Affected Products – RSE/RSOE series

Dear customers and distributors, we herewith inform you about Product Change Notice* concerning the following products:

RSE, RSOE series (all versions).

Series	Component (before)	Component (after)
RSE and RSOE	PCB code: DCS-707	PCB code: DCS-707 rev.B

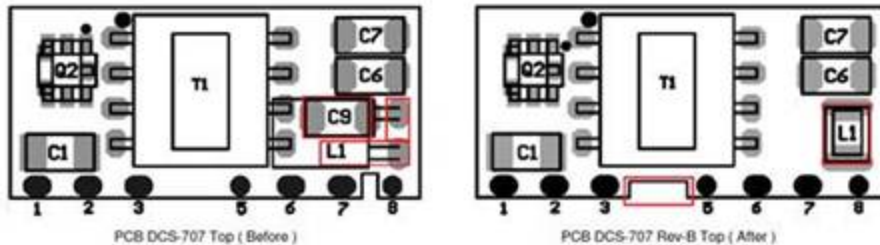
The electronics industry is moving to smaller-sized passive components and discontinuing the larger size formats. For example, 1206 resistor dimensions are migrating to 0805. It is therefore necessary to change the internal PCB layout of these products to accommodate the smaller standardized sizes.

We have also taken the opportunity to rearrange some the components on the PCB now we have more room and, in particular, to switch from through-hole to SMD-mount inductors. This is to improve the production yield and performance stability by increasing the automation grade of the converters.

The new PCB layout is identified by a notch between pins 3 and 5 so that it can be more easily identified by x-ray inspection after assembly.
